Access Compliance Report

Public Rights-of-Way (Curb Ramps)

Intersection ID: 17352	Main Street: BRANTHAM_CT	Cross Street: WALKER_RD	Location: SW
ADA ID: EA05B2569BD5	Ramp Type: PerpDiag	Initial Pass/Fail: Fail	Overall Compliance: No
Severity Score: 22.5			
Codes/Mitigation Info/Possible Solution		Field Measurements/Component Compliance

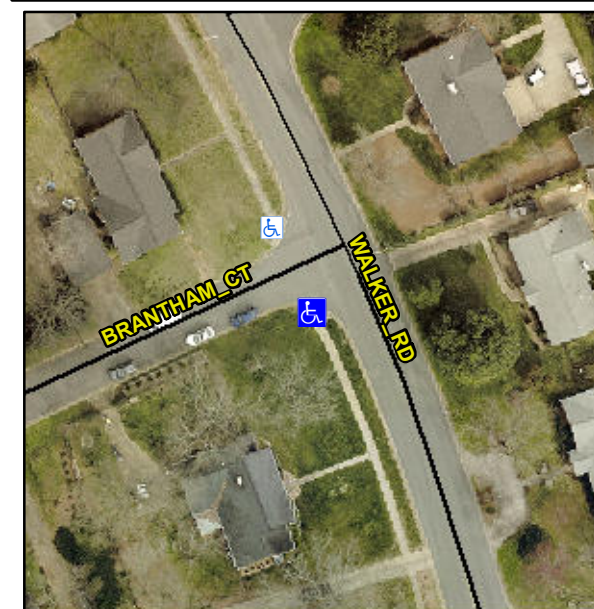
Not Found, R304.5.1, R304.2.2, R304.5.3

Compliance	Description	Data	Compliance	Description	Data
N/A	Ramp Length (in)	29.0	No	Ramp Slope (%)	9.0
No	Ramp Width (in)	43.0	No	Ramp XSlope (%)	2.1
N/A	Flare Type LT	N/A	N/A	Flare Type RT	N/A
N/A	Flare Slope LT (%)	N/A	N/A	Flare Slope RT (%)	N/A
N/A	Flare Traversable LT?	N/A	N/A	Flare Traversable RT?	N/A
N/A	Landing Length (in)	N/A	N/A	DWS Provided?	N/A
N/A	Landing Width (in)	N/A	N/A	DWS Contrast?	N/A
N/A	Landing Slope (%)	N/A	N/A	DWS Length (in)	N/A
N/A	Landing X Slope (%)	N/A	N/A	DWS Full Width?	N/A
N/A	Landing Curb? (Y/N)	N/A	N/A	DWS Offset (in)	N/A
N/A	Shared Landing?	N/A			
N/A	Gutter Ponding?	N/A	N/A	Gutter Slope (%)	N/A
N/A	Gutter Lip Ht (in)	N/A	N/A	Gutter X Slope (%)	N/A
N/A	Painted X Walk1?	No	N/A	Painted X Walk2?	No
	X Walk 1 Direction	To E		X Walk 2 Direction	To NW
N/A	X Walk 1 Width (in)	N/A	N/A	X Walk 2 Width (in)	N/A
	X Walk 1 Slope (%)	8.1		X Walk 2 Slope (%)	4.0
	X Walk 1 X Slope (%)	3.0		X Walk 2 X Slope (%)	3.3

Remove & Replace Curb Ramp With Two New Directional Ramps or Equivalent.
